To: Risse, Geoffrey
Subject: RE: Can-Am Plumbing (RO#0002425) CPT work

Subject: Fuel Leak Case No. RO0002425 and Geotracker Global ID T0600156201, Can Am Plumbing, 151 Wyoming Street, Pleasanton, CA 94566

Alameda County Environmental Health (ACEH) has reviewed the case file for the above referenced site including the recently submitted document entitled, "Additional Subsurface Assessment Work Plan," dated October 9, 2007 and prepared on your behalf by Gettler-Ryan, Inc. The Work Plan proposes four cone penetrometer borings to further delineate the horizontal and vertical extent of petroleum hydrocarbons in groundwater north and east of the site. We concur with the proposed scope of work described in the Work Plan.

Original EXTENDED SITE PLAN
 Con-Ar Plumbing
 151 Wyoming Street,
 Pleasanton, California

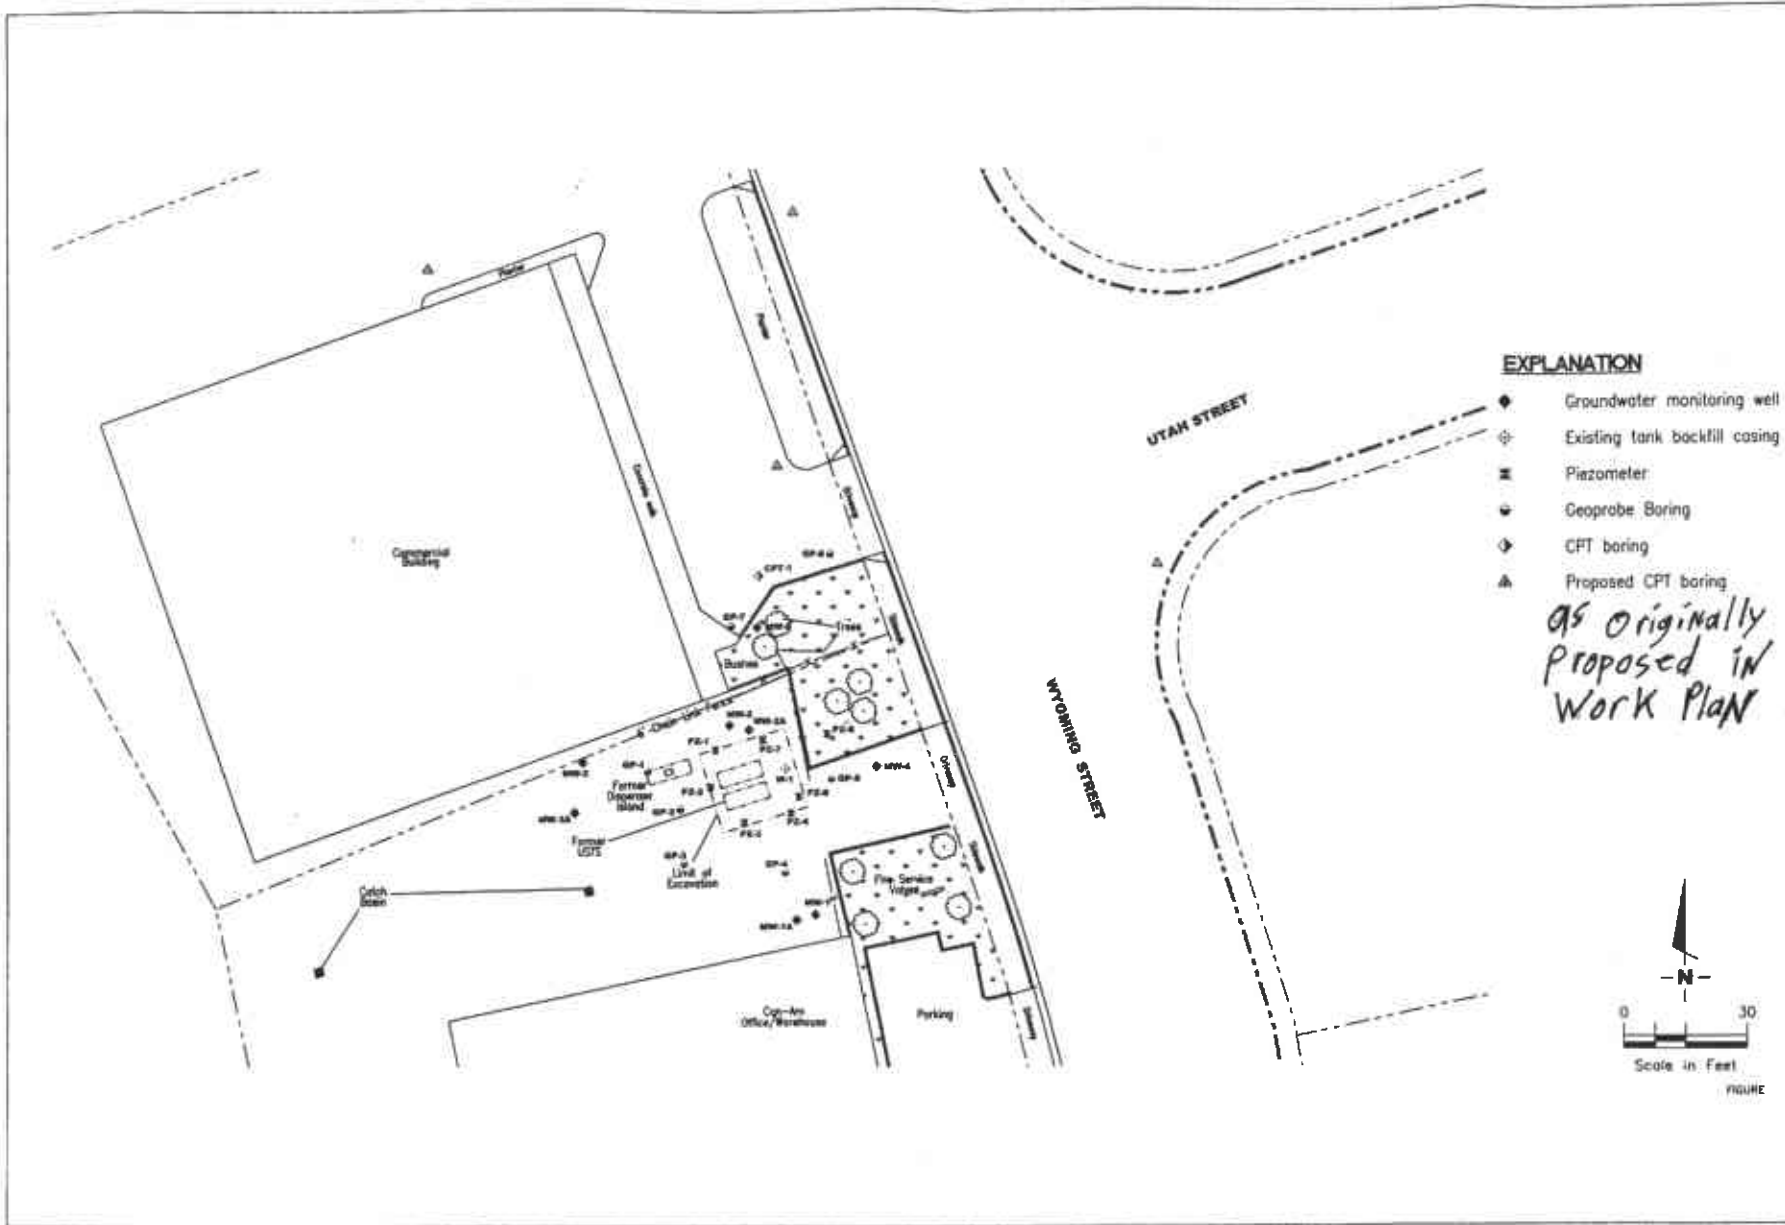
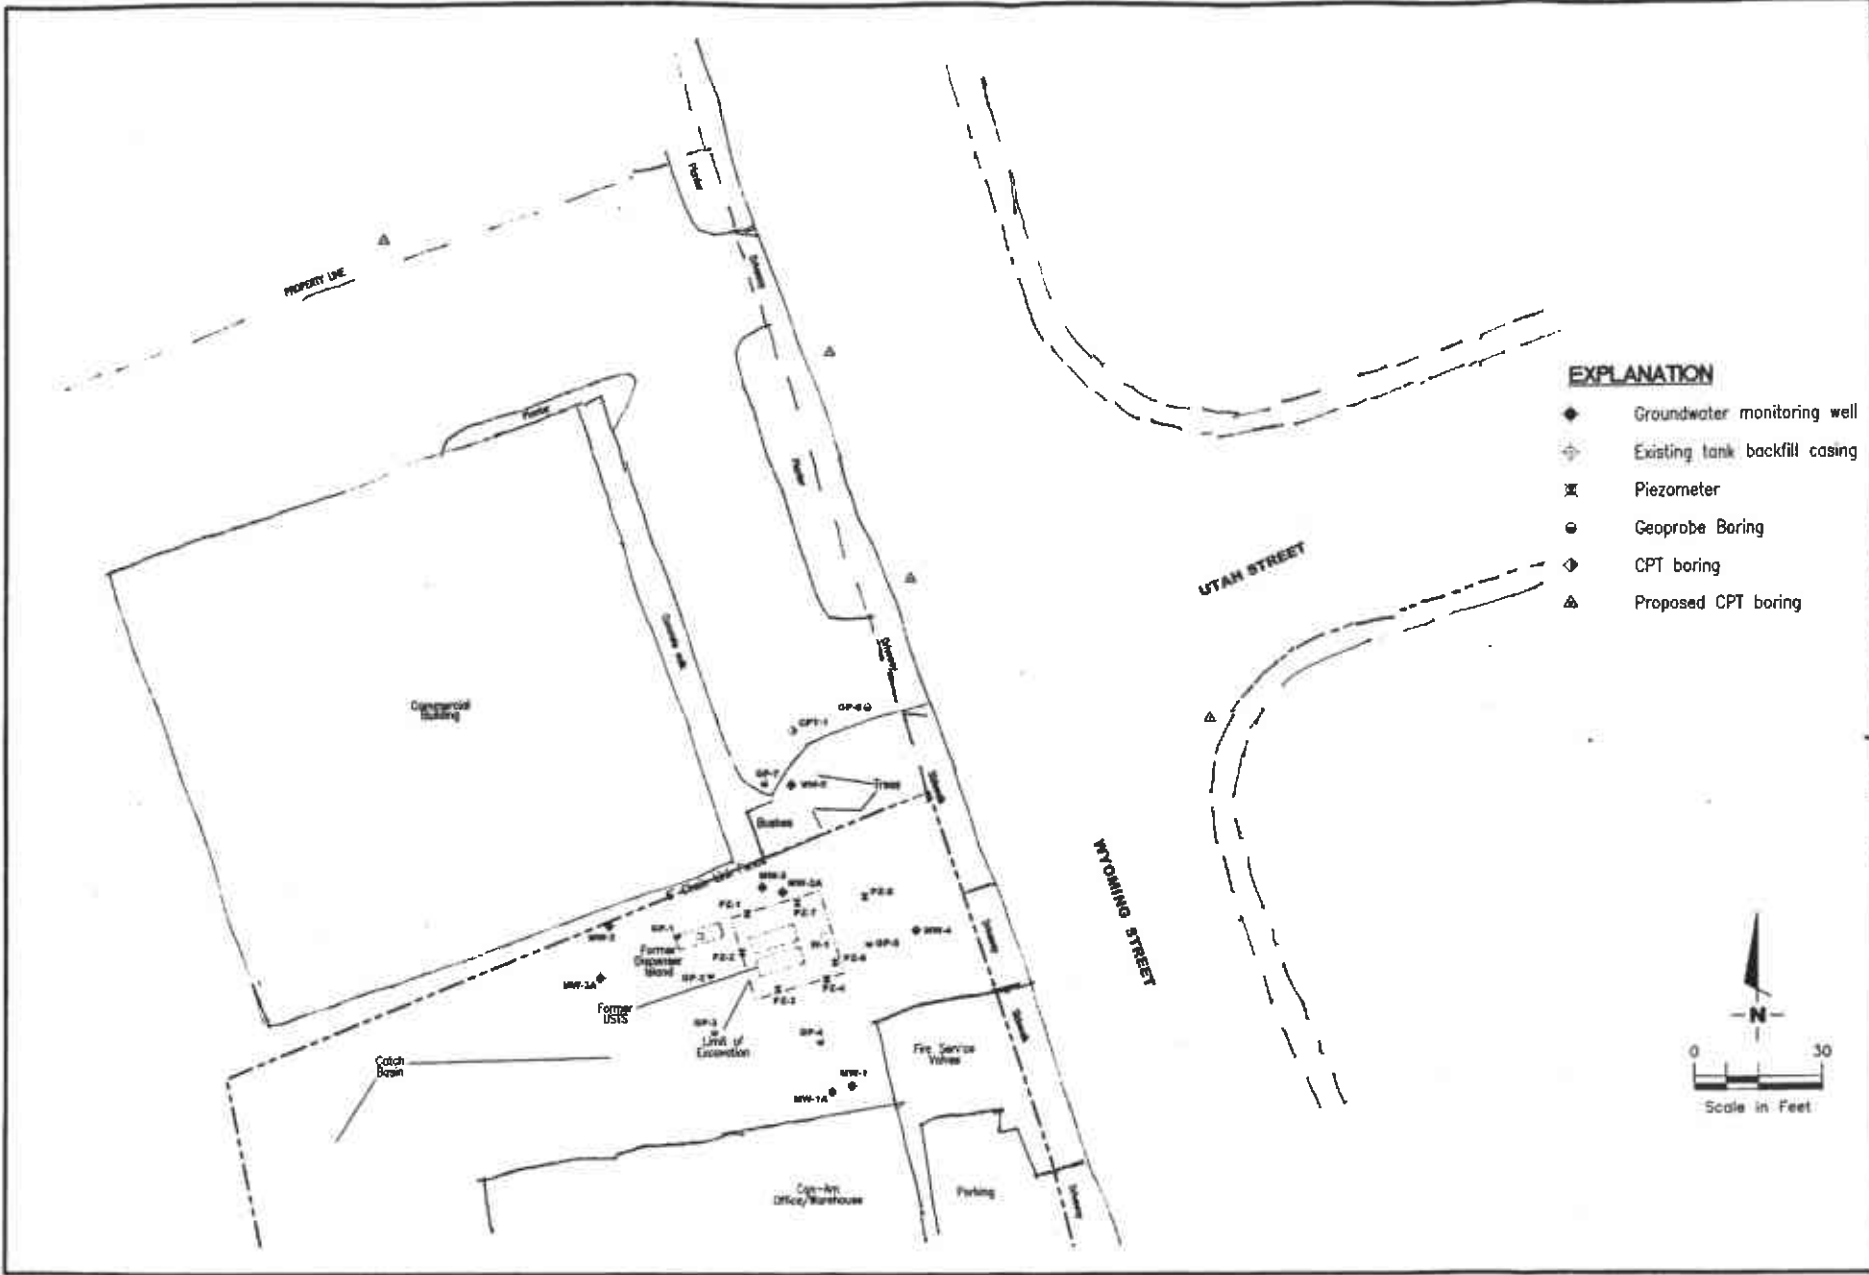
While out marking the CPT boring locations out at Can Am Plumbing as proposed in our Additional Subsurface Assessment Work Plan, Gettler-Ryan had a meeting with the adjacent property owner. He is refusing to allow us access to drill the two CPT borings in his parking lot as proposed on the attached original extended site plan. Therefore, Gettler-Ryan proposes to move these two borings to the locations as shown on the attached modified extended site plan.

Please let us know if these new locations are acceptable. Thank You.

I have no objection to the proposed modified boring locations.
